MARK	DATE	DESCRIPTIONS	BY	CH'D	CCO#
0	05/06/11	MEP INTEGRATION REV. & UPGRADES TO SYSTEMS	TW	RG	163

CONTRACT CHANGE ORDER NO. 163
SHEET 3 OF 32

SKYWAY ROADWAY LEVEL EASTBOUND LIGHTING AND ELECTRICAL SYSTEMS

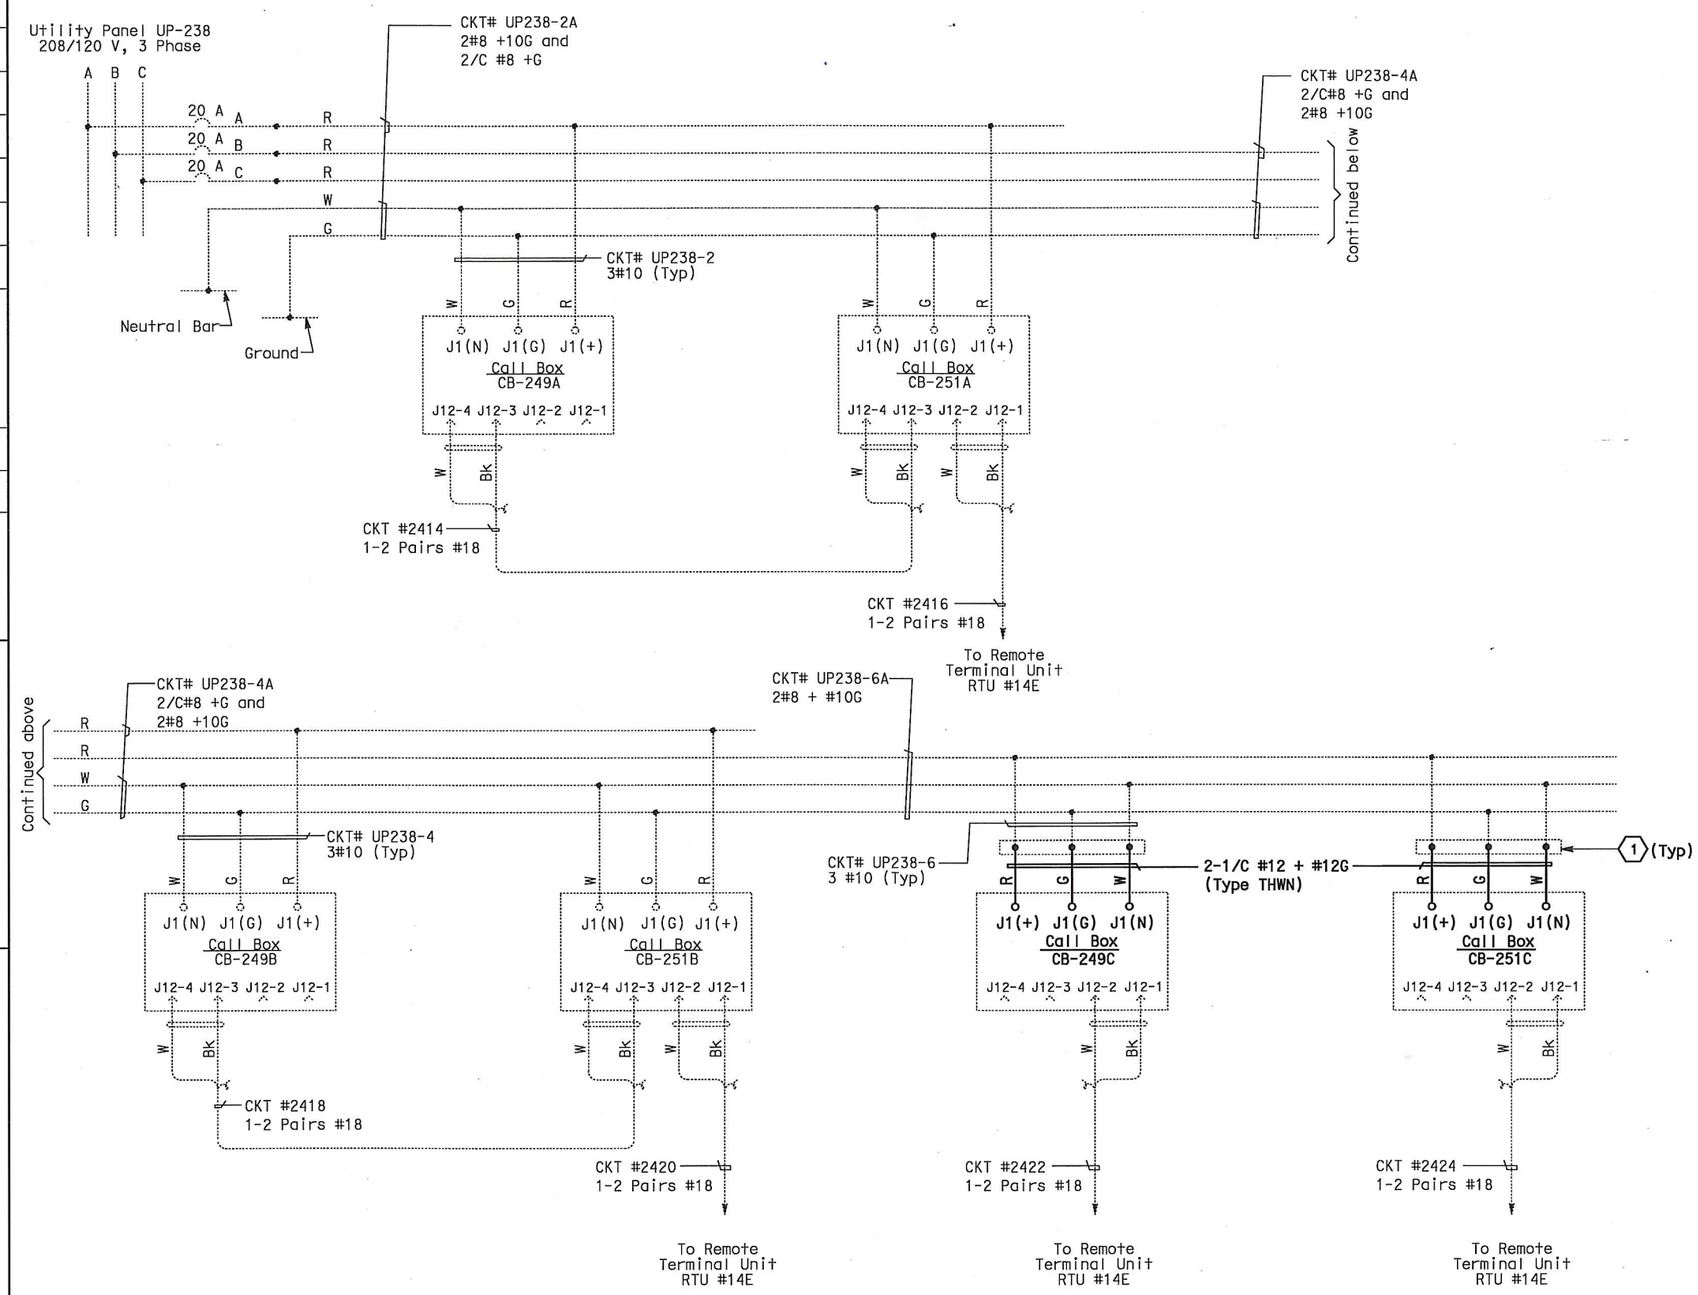
(1) Existing pull box mounted below bikepath. See Details on sheet E-165L.

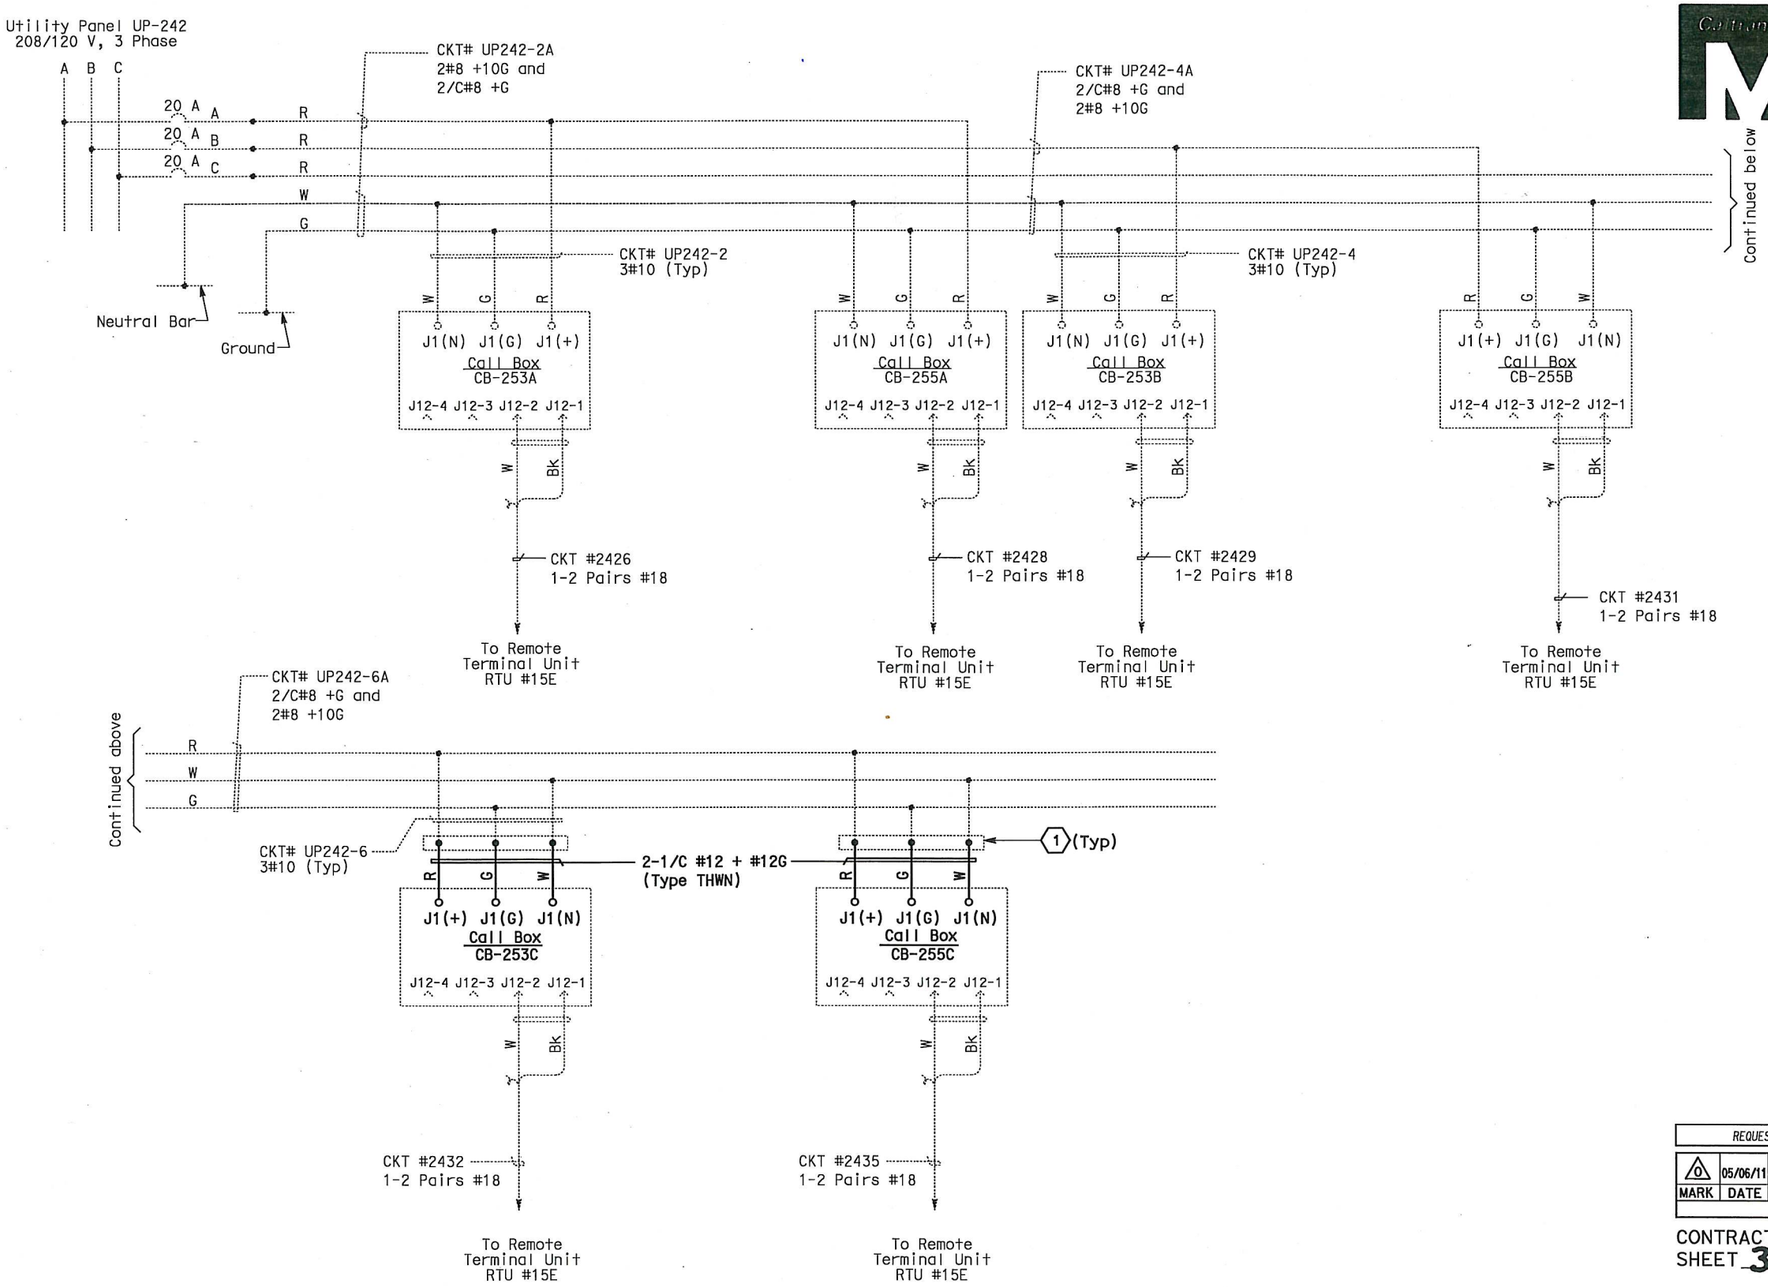
(1) Existing pull box mounted below bikepath. See Details on sheet E-165L.
